MEMORANDUM

B1 - MEANS OF ESCAPE OBSERVATIONS

PREMISES: Grenfell Tower

SUBMISSION No: Preliminary (P1)

OFFICE LEVEL

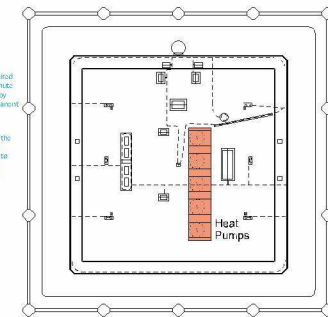
15. Items 2, 3, 8 and 10 as given above also apply at this level.

WALKWAY LEVEL

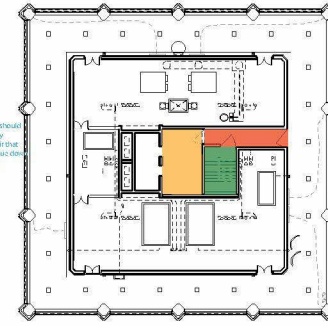
13. The common stair serving the upper floor levels should connect directly to the common stair serving the lower floor levels that leads to the final exit at ground floor level. The common stair serving the upper floors as shown on the plan seems to show the stair being accessed from the common lobby which would not be appropriate.
14. Items 2 and 3 as given above also apply at this level.
